BOARD OF ADJUSTMENT STAFF REPORT

MEETING DATE: February 26, 2024
AGENDA ITEM TITLE: Sundry Variance Application -135 West First Street
AGENDA SECTION: Public Hearing

REQUEST: The request is to receive a variance from the maximum building height of 35 feet in the C-2 Central Business District. The applicant is requesting a maximum allowed height of 38 feet for the rear portion of the building and 40 feet for an elevator shaft towards the center of the building for ADA accessibility.

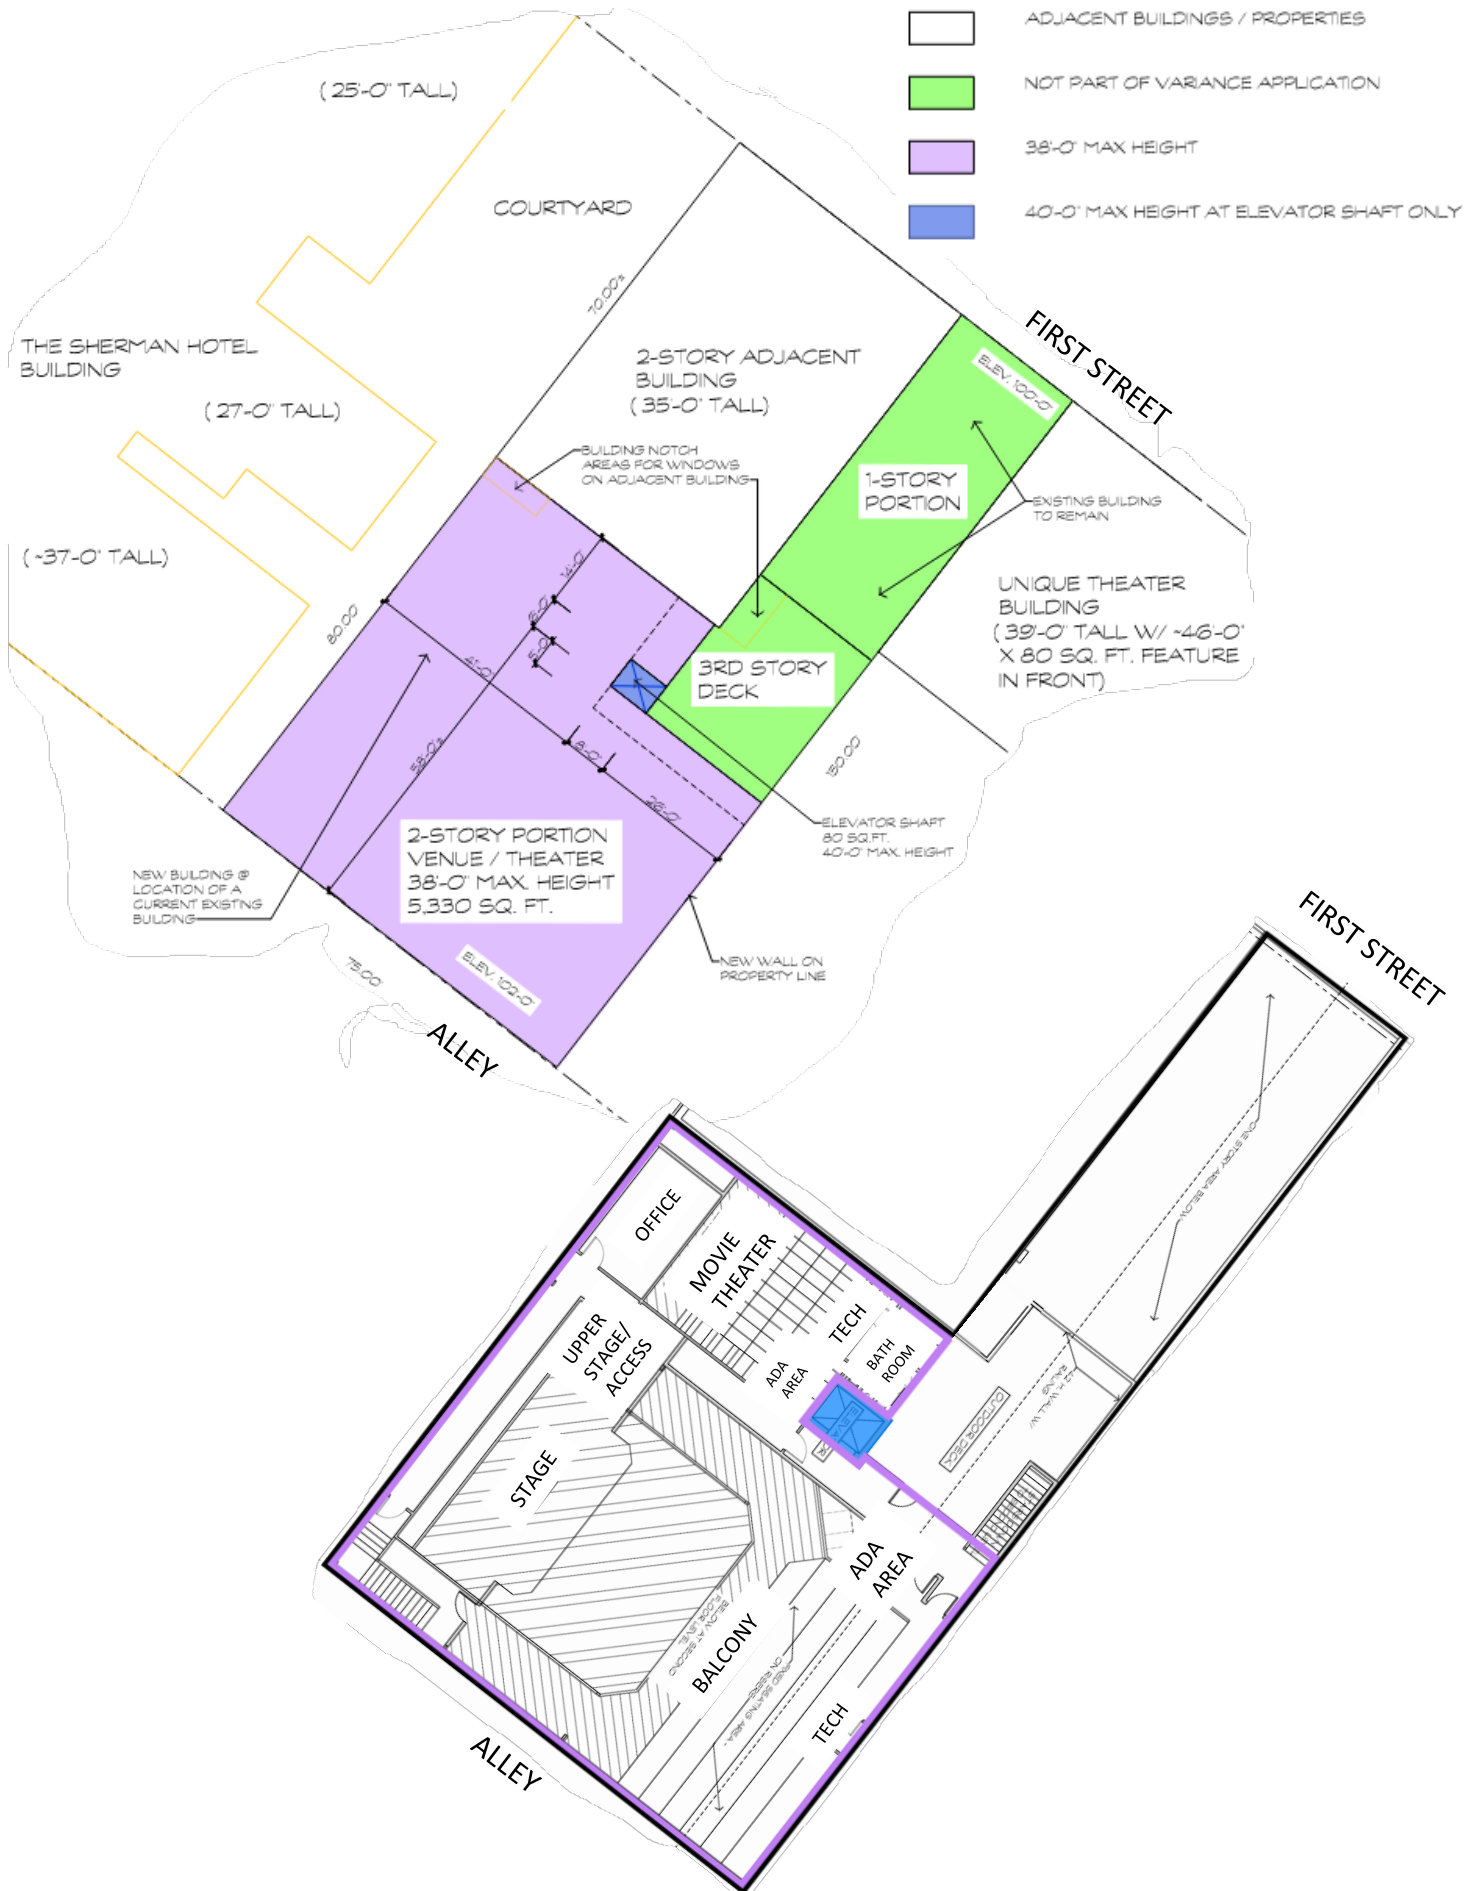
- c. The purpose of the Central Business Economic Overlay is to establish standards to preserve and protect the downtown area as a viable commercial district, and to ensure that future development be designed and planned in a manner compatible with those goals.
3. In order to construct a theater with the desired features, such as unobstructed sightlines from the balcony seating area to the stage and screen, good accessibility for patrons, and one that meets the egress requirements, the applicants are requesting a variance from the 35 foot maximum height currently allowed by Code. The request is to be allowed 38 feet in height for the rear portion of the building (shown in purple below) and 40 feet for the elevator shaft for ADA accessibility (shown in blue).

Staff Comments: The special circumstances are twofold; one, that due to the topography of the lot, the larger portion of the lot, which has the space to contain the venue, loses a foot of height based on how height is measured by the Code, and secondly, that this is a unique use with unique requirements to be a successful venue in the Central Business District. Special circumstances exist because a vibrant and functional theater and event venue has specific structural and accessibility needs to meet the expectations of today's audiences and to ultimately be successful.

Staff recommends the Board of Adjustment **APPROVE** the Sundry Variance request to receive a variance from the maximum height of 35 feet to allow up to 40 feet in height for the elevator shaft only, and up to 38 feet in height for the rear portion of the venue.

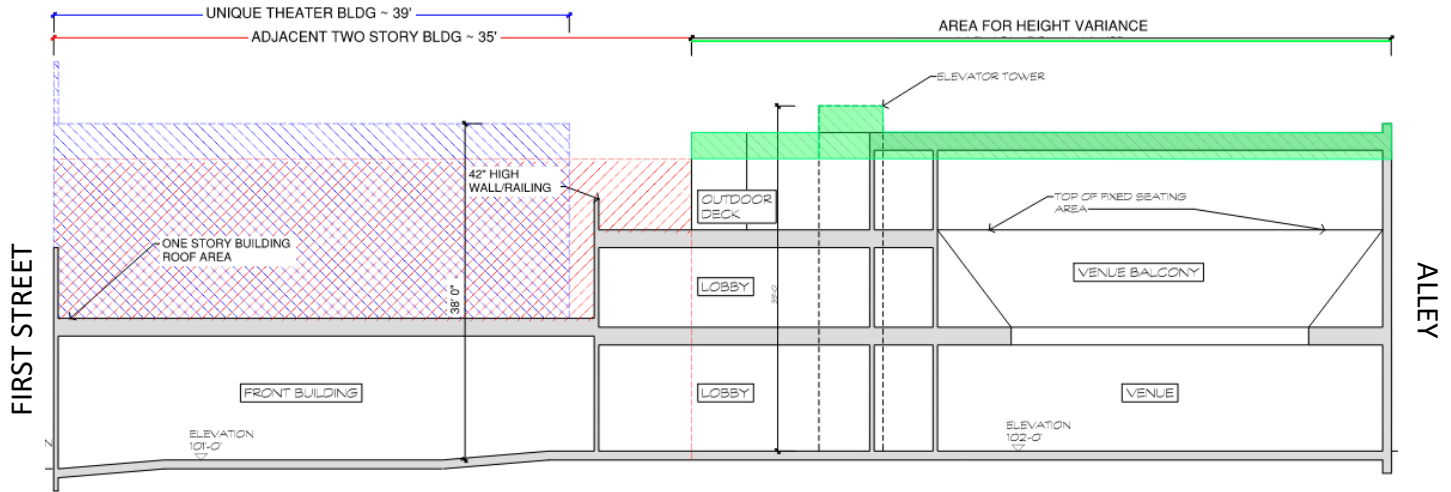
Both will be maintained in the proposed project. The Sundry will remodel and update the First Street façade, restoring its historical features with a modern take to compliment the surrounding downtown buildings while maintaining a height that is within a few feet of the existing front. The pedestrian view from the sidewalk will be virtually the same. The rest of the project will replace the current rear portion of the building, starting ~70'-0" back from First Street. The requested height variance areas are located to the rear of the property and out of the public view corridors. See the attached Diagram XI, photos, and 3D views (X2 – X4).

Staff Comments: As stated above in the purpose statements of the three layers of zoning on this property, this proposal will not impair the intent and purpose of the Code, but rather, allow for the intent and purpose to be met in a viable way. This site is intended to provide for concentrated commercial activity that serves the needs of the entire community and of visitors to the community; to ensure development is compatible with and enhances the historic, cultural and architectural heritage of the City; and to ensure that future development is designed to preserve and protect the downtown area as a viable commercial district.
